Subject: **THIRD RESPONSE TO PEER REVIEW**
Phase 2 of Tentative Tract 37-46
White Mountain Estates Subdivision
Chalfant Valley, Mono County, California

Reference: Review of Revised Site Geologic Map
Phase 2 of Tentative Tract Map No. 37-46
White Mountain Estates Subdivision
Chalfant Valley, Mono County, California
Prepared by AMEC Earth & Environmental dated June 13, 2006

GEOLOGIC LOG OF TRENCH T-12
SHEETS 1 – 6 OF 6

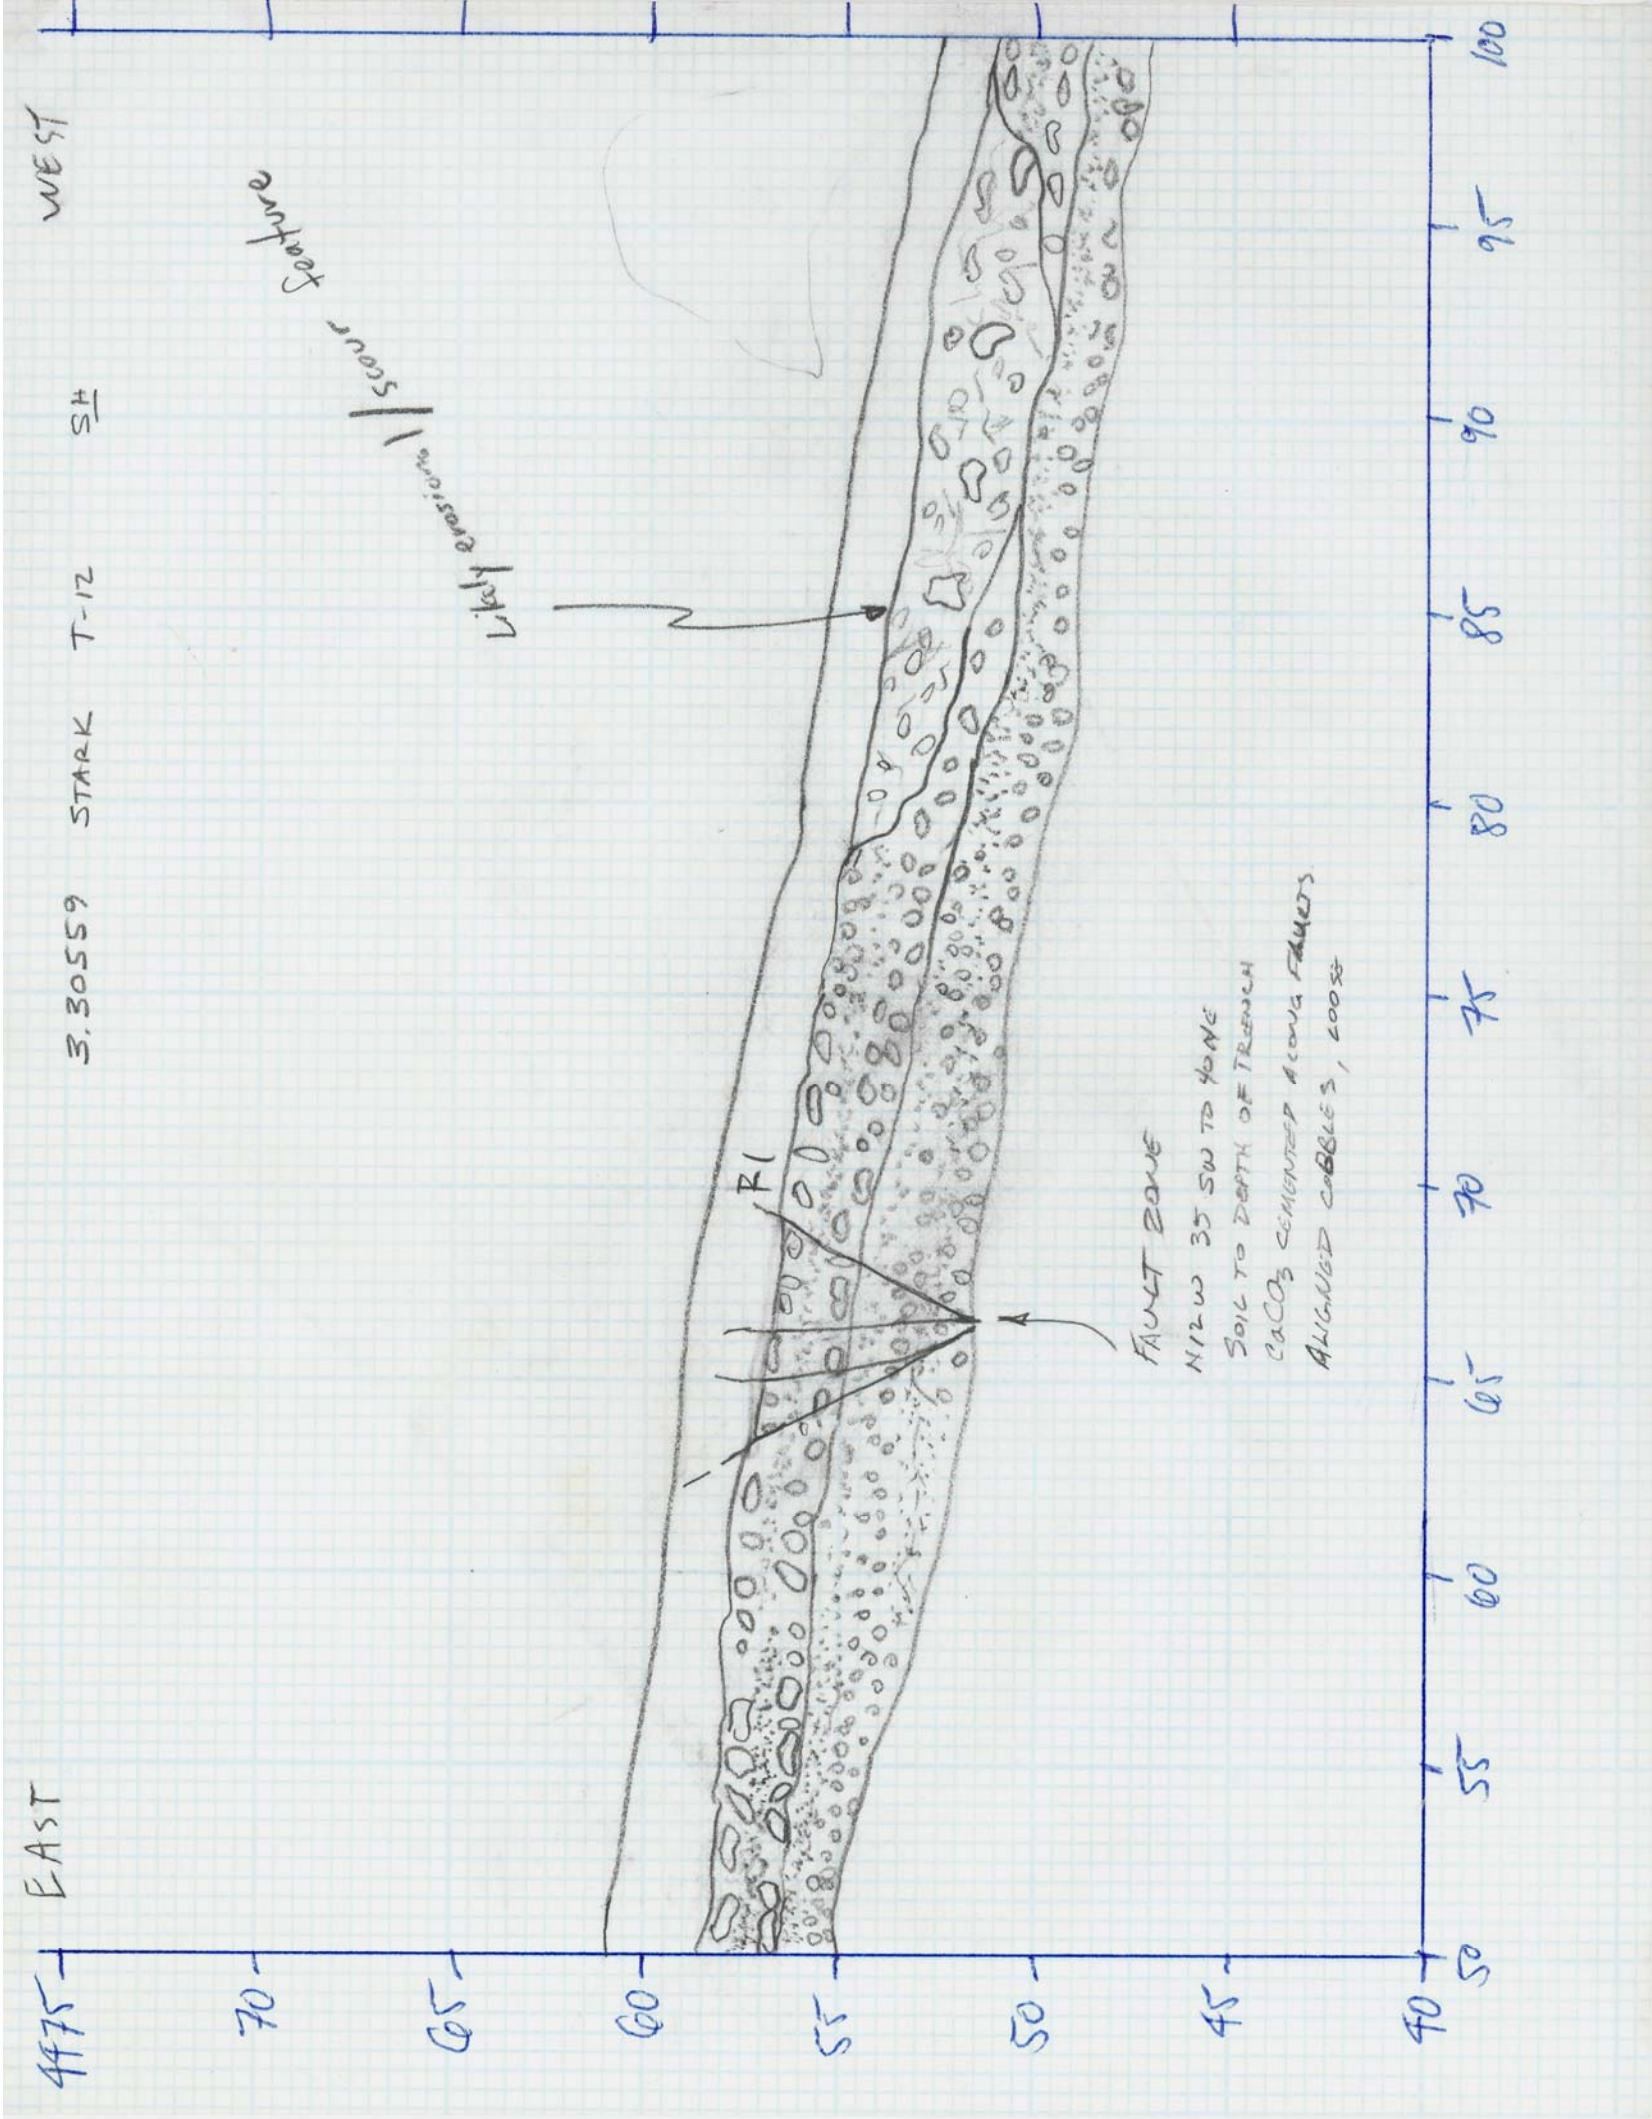
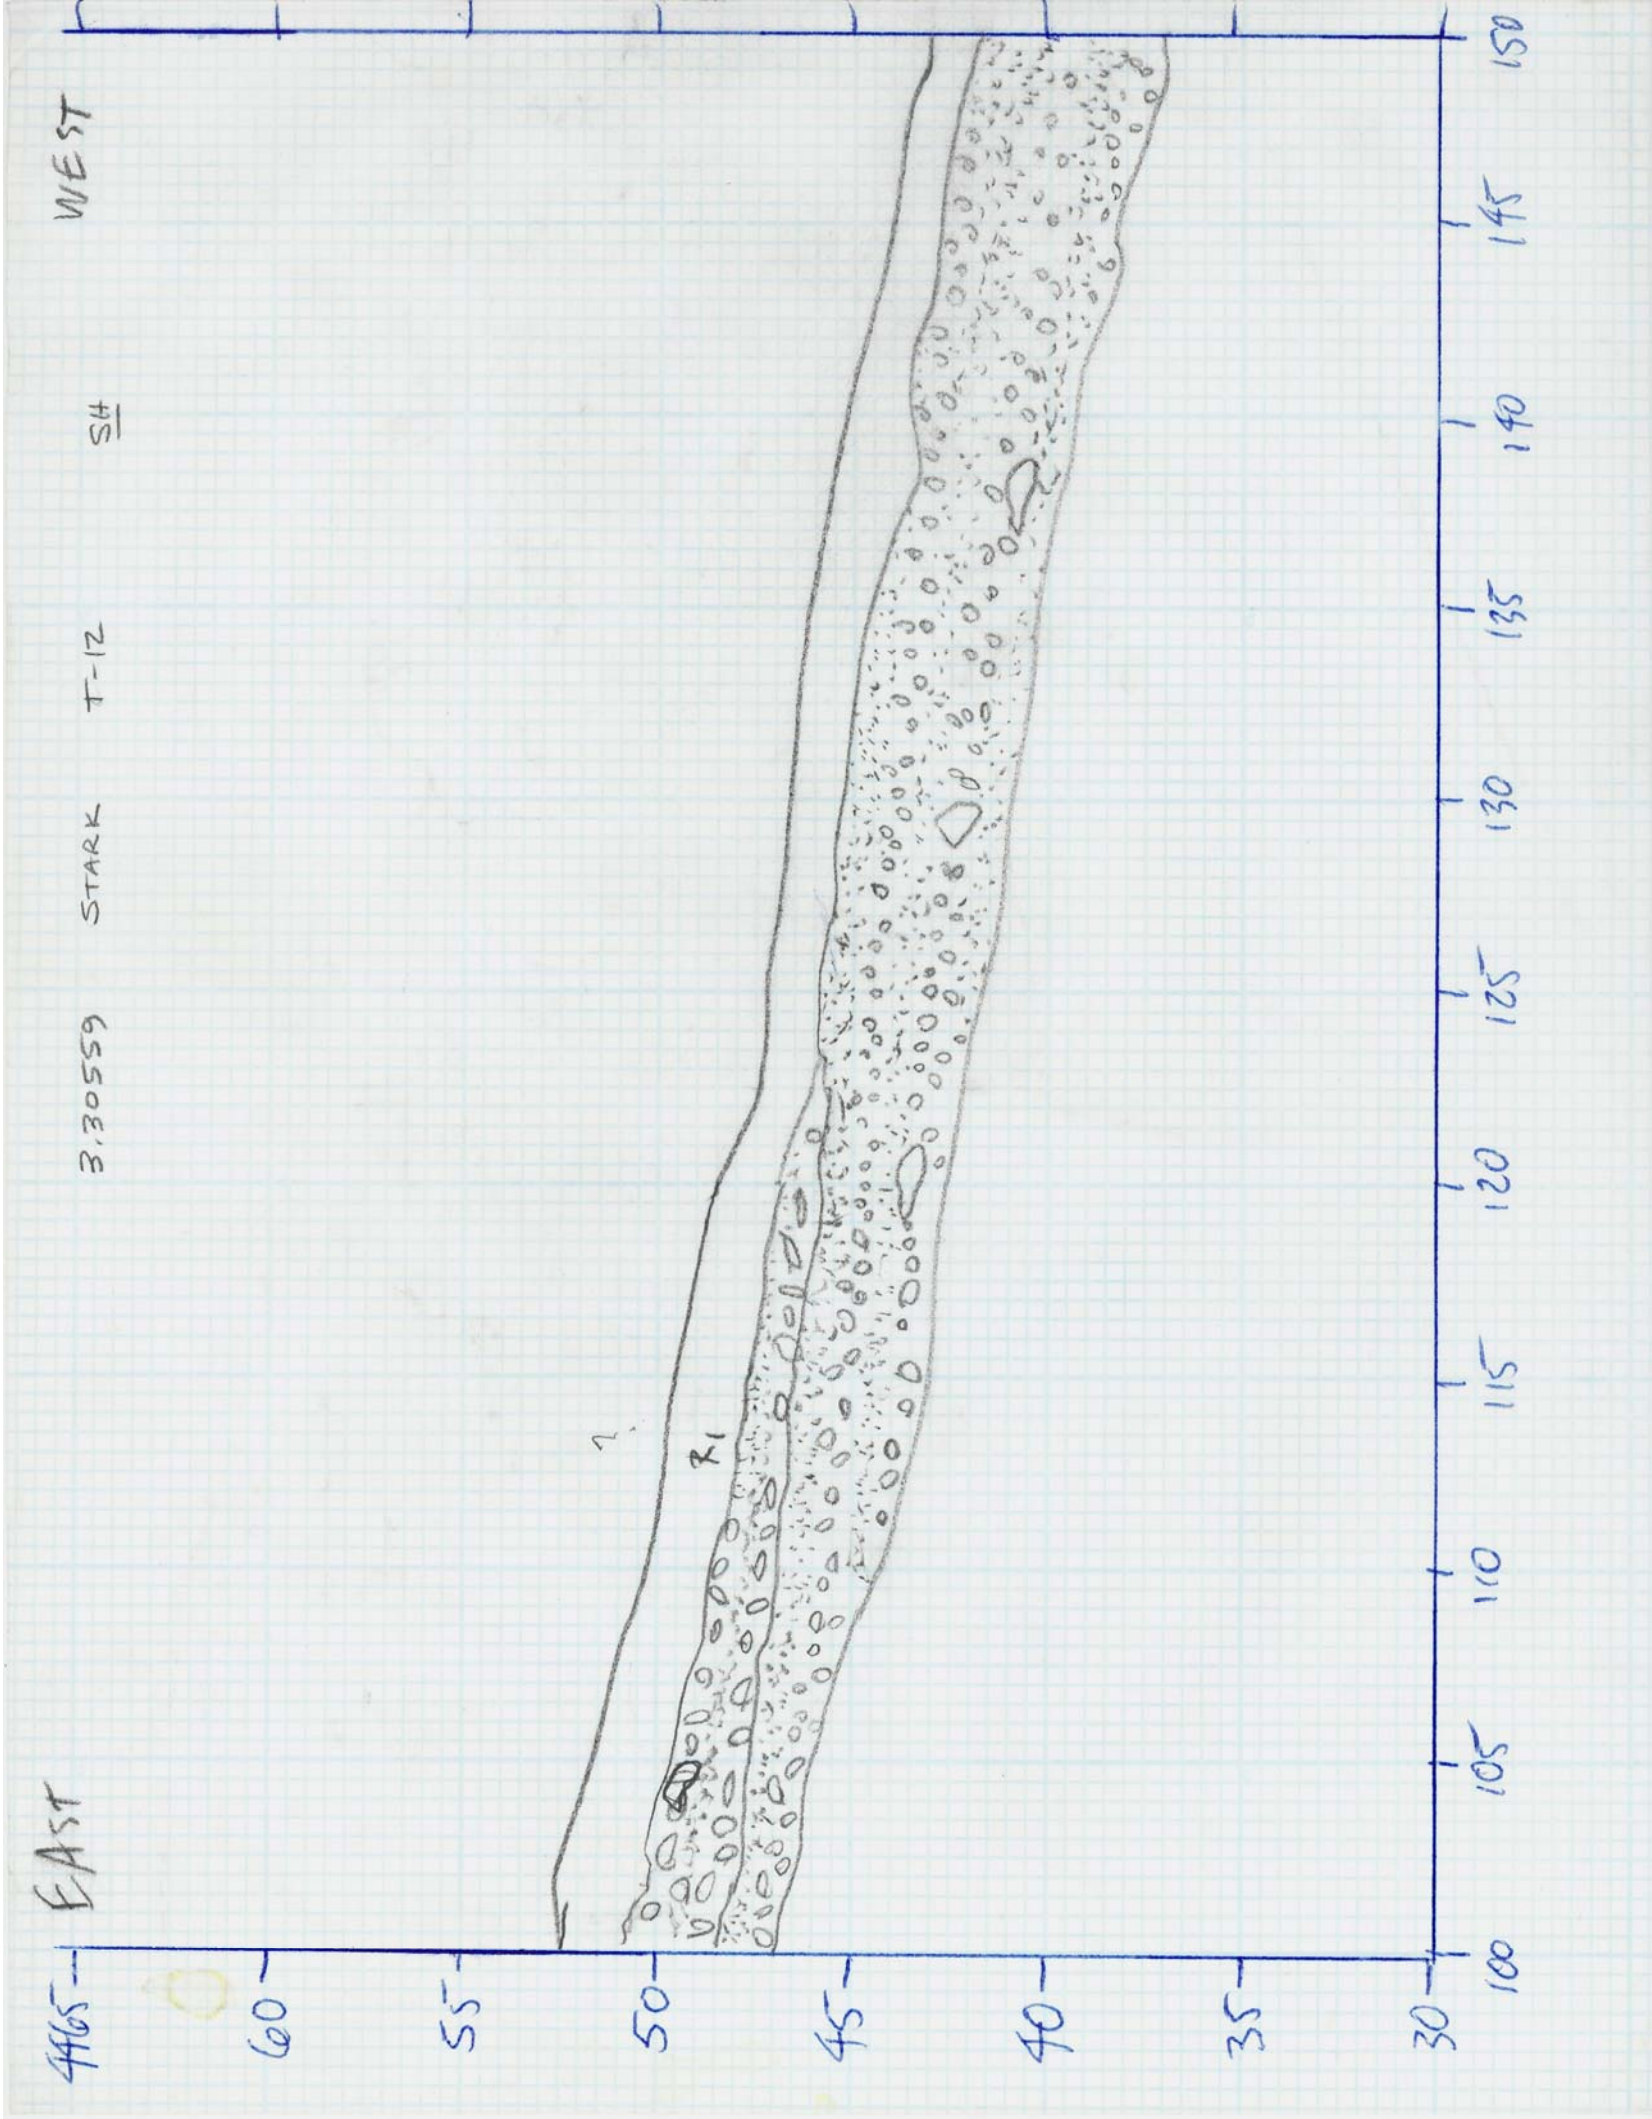
Due to the uncertainty associated with the location or projection of active fault features from the existing exploratory fault trenches it is recommended that Minimum building areas be established for each lot within the existing habitable zones. Building areas that can be established immediately adjacent the existing fault trench excavations are approved with respect to active faulting based on the existing data. Proposed building areas that are more than 50 feet from an existing fault trench will require additional subsurface fault trenching to establish that the building area is free of active faulting. The location of any proposed additional fault trenches, to substantiate the validity of a proposed building area, should be reviewed and approved by the geotechnical consultant for Mono County prior to excavation and logging. The designation of acceptable building areas, verified by the existing fault trench data or new fault data as discussed above, should be accomplished prior to Mono County's approval of the tract.

Response: Two additional fault trenches were proposed and located upon approval via telephone and email from the geotechnical consultant (AMEC) for Mono County. Each trench was located to provide additional data within those habitable areas that had been previously established by rather lengthy projections. Additional Fault Trench T-11 was excavated and logged across the habitable zone that traverses proposed Lot 43, and additional Fault Trench T-12 was excavated and logged across the habitable zone that traverses proposed Lot 41. Each trench exposed faulting OUTSIDE of each habitable

zone as was anticipated from our previous findings. Faulting was NOT observed within either habitable zone on either lot. Therefore, we have revised each habitable zone to reflect these findings, and they are shown on the attached Revised Site Geologic Map. Based on the dimensions of the largest footprint of the manufactured homes that are proposed for the subject site, Minimum Building Areas (MBA) have also been established for each lot within each revised habitable zone. It should be noted that each MBA location is provided to demonstrate fit and buildability within the habitable zone only; they are not intended to restrict structures to that location or dimension. The west side of the habitable zone across Lots 40 and 42 has been revised such it is now setback fifty feet from the nearest mapped fault to the west, and as a result the MBA on Lot 42 has been repositioned inside the habitable zone such that there is still adequate room for a habitable structure. Additionally, the habitable zone has been removed from proposed Lot B Common Area for Phase 1 of Tentative Tract 37-46 since the proposed water storage tank and propane tanks are not habitable structures; however, their proposed locations have been plotted such that they are as far away as possible from the nearest mapped faulting on this lot in order to minimize the potential for disruption or damage to the tanks from future ground surface rupture-causing events.
